**Tyres: UN Regulation No. [164] (Studded tyres)**

## **Proposal for Supplement 1 to UN Regulation No. [164]**

### **Submitted by the Task Force on Studded Tyres\***

Figure 1:  
Pictogram definition of "Snow Grip Marking Symbol for Studded Tyres"

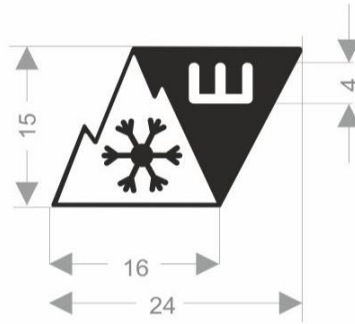
- 4.1. All tyres constituting the type of studded tyre shall be marked as prescribed by either UN Regulation No. 30 or 54, as applicable.
- 4.2. **Tyres type approved under this Regulation**~~In particular tyres meeting the requirements of paragraph 6.1. below, shall bear:~~<sup>4</sup>
- 4.2.1. **the word "STUDED" at least 4 mm in height.**
- 4.2.1.2. **The Snow Grip Marking Symbol for Studded Tyres as defined below in Figure 1 in case the tyre meets the requirements of paragraph 6.1.**

Figure 1 — stud protrusion device sketch

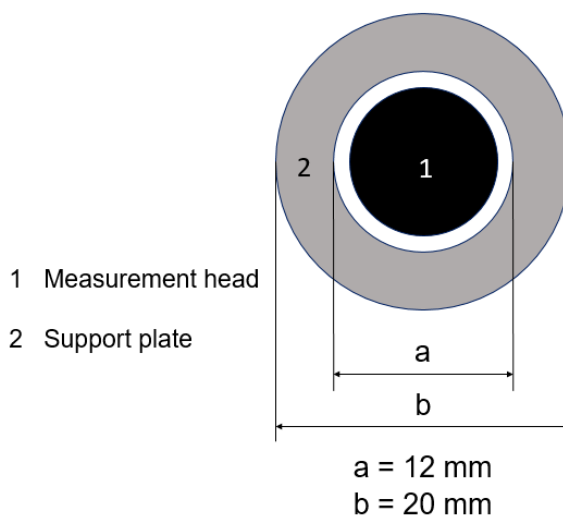
The stud protrusion measurement shall be done under the inflation pressure conditions required by the ice grip test. Figure 1 illustrates the stud protrusion device. It shall be equipped with a support plate (2) of 20 mm diameter and a 12-mm diameter hole for the measurement head (1). The measurement head shall be pressed perpendicular to the tread surface with a force of 15 N to 20 N to trigger the measurement. The stud protrusion shall be measured from every test tyre, from 20 consecutive studs over the whole width of the tread and in circumferential direction, and at the same stud positions each time.
